Historic Landmark Commission

Memorandum

Re: Stevig Residence Follow Up (PLNHLC2012-00624 – New Construction and
PLNHLC2012-00696 – Special Exception for Height)

date:
 JAN 31, 2013 REVIEW SET

sheet title:
 EXTERIOR
 ELEVATIONS

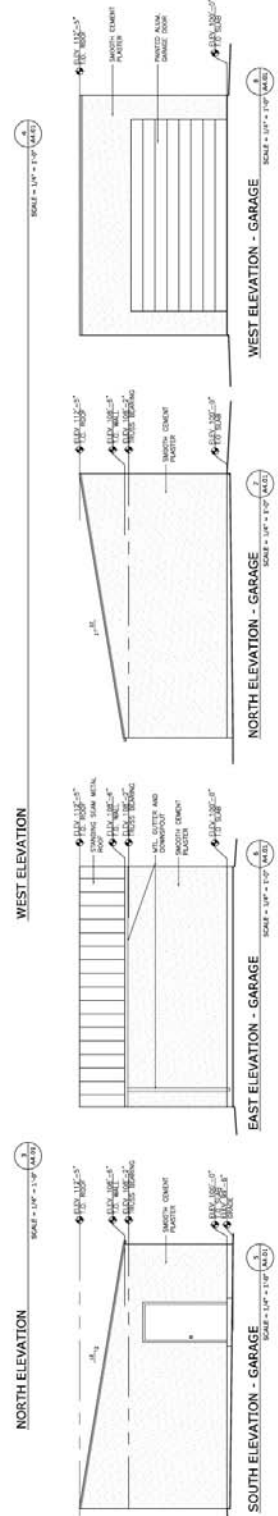
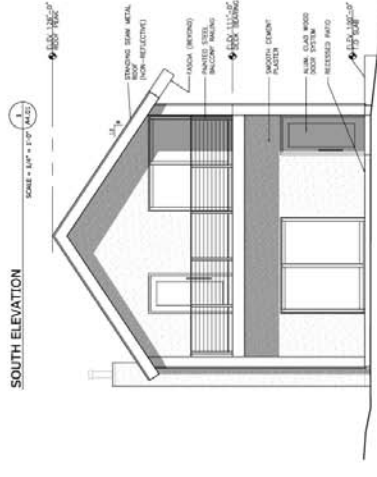
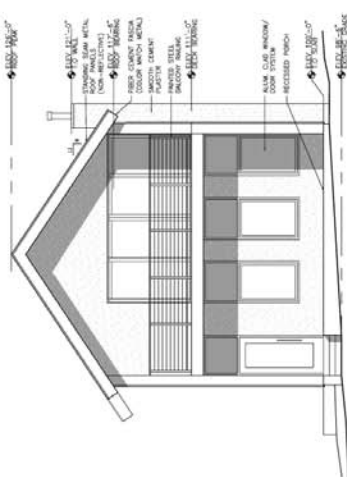
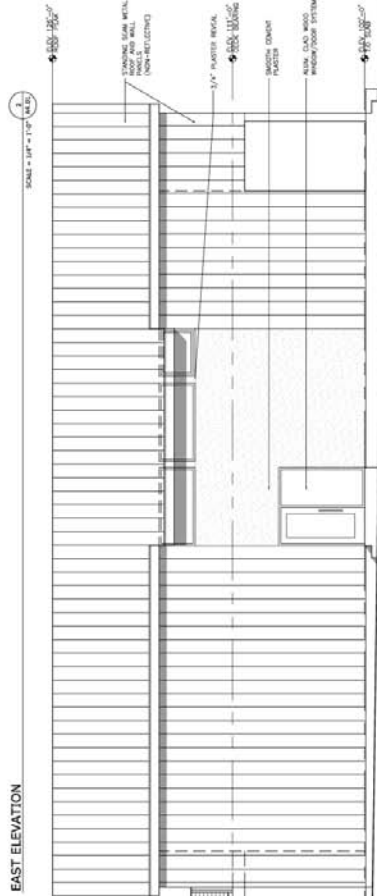
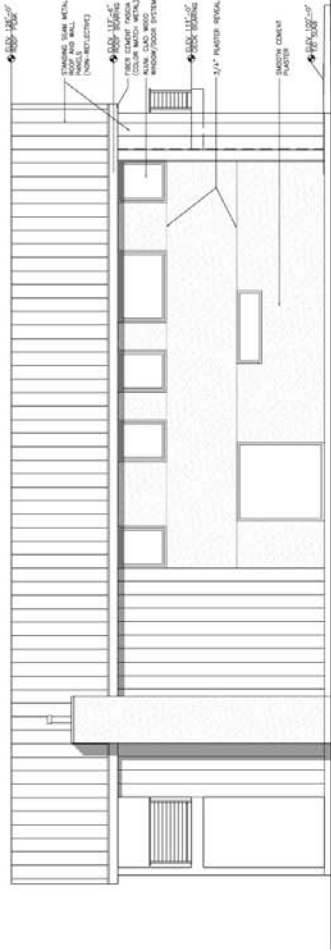
1. Eaves were added to the second story of both the east and west sides of the residence. The west side elevation has an additional eave that resembles an awning over the three second story windows.

2. The north or rear elevation does not have as much of the standing metal seam panels extending the side walls and roofline around and over the ground floor patio or second story balcony. The second story balcony now projects from the residence and is not hidden by the wrapped metal panels.

3. The south or front elevation has had three of the four sides of the covered porch area opened up. The only one that is not opened up now is on the west side of the upper level. This side was not opened up so the owner could have some privacy from the gasoline service station to the west.

4. On the east and west elevations, additional metal siding has been added. The area where it has been added on the east elevation is between the fireplace and the second story windows. On the west elevation, the additional metal has been added between the second story windows and the covered front porch. On both elevations, metal siding was removed where the front porch has been opened up, but overall, there is more of the metal siding on the both elevations.

5. The five second story windows on the east elevation have been rearranged. The number of windows is the same, but the placement is different.

- Second story windows on the east elevation have no rhythm. They appear to just be placed on the side and no thought was given as to how they relate to the rest of the building.

sheet title:
EXTERIOR

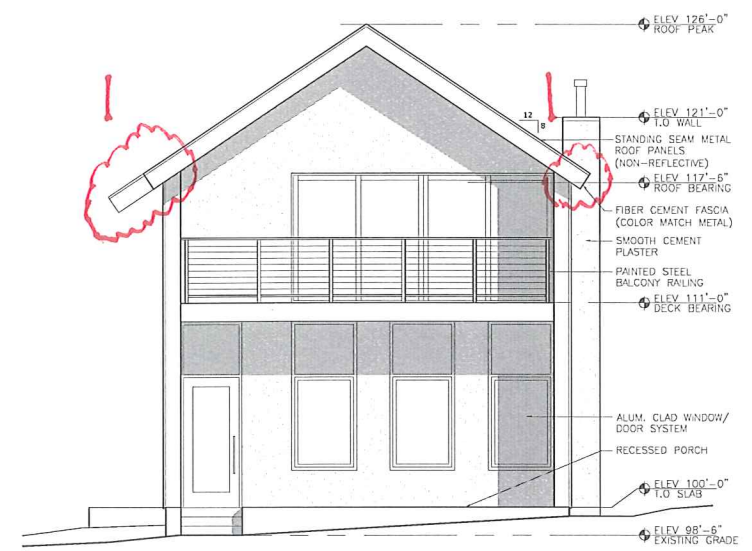
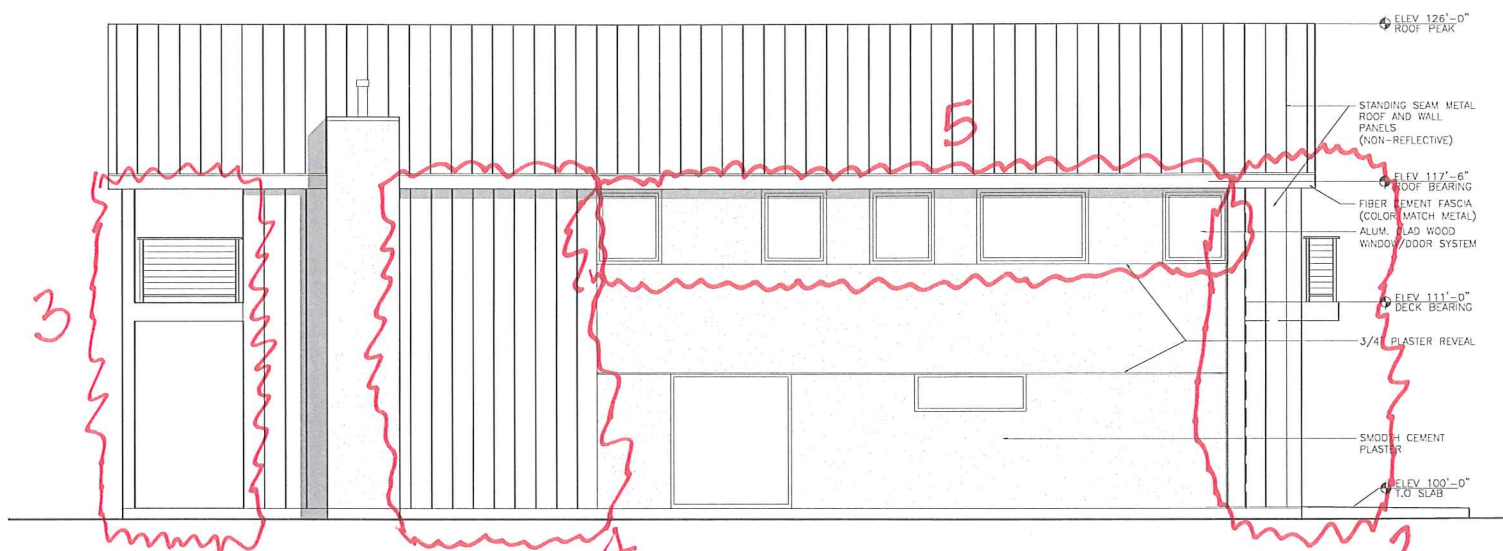
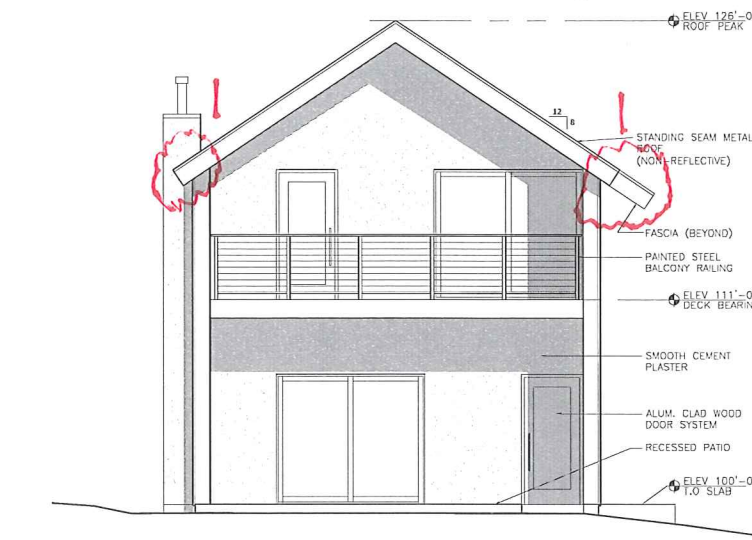
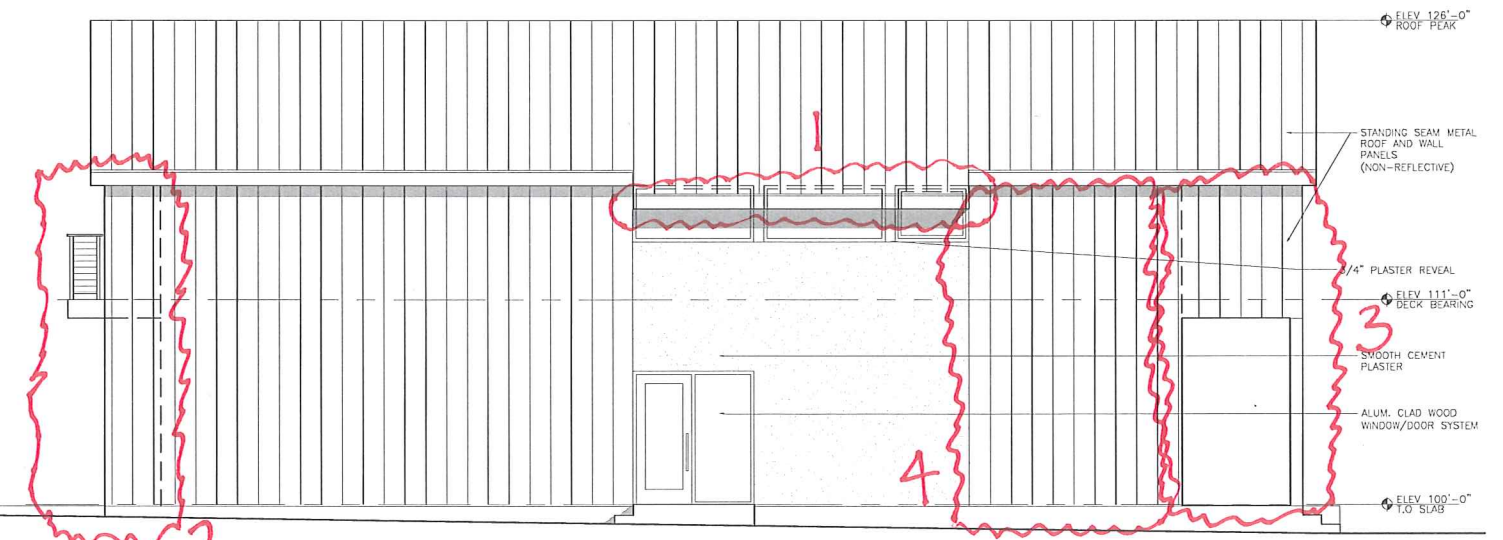
1. Eaves were added to the second story of both the east and west sides of the residence. The west side elevation has an additional eave that resembles an awning over the three second story windows.

4. On the east and west elevations, additional metal siding has been added. The area where it has been added on the east elevation is between the fireplace and the second story windows. On the west elevation, the additional metal has been added between the second story windows and the covered front porch. On both elevations, metal siding was removed where the front porch has been opened up, but overall, there is more of the metal siding on the both elevations.
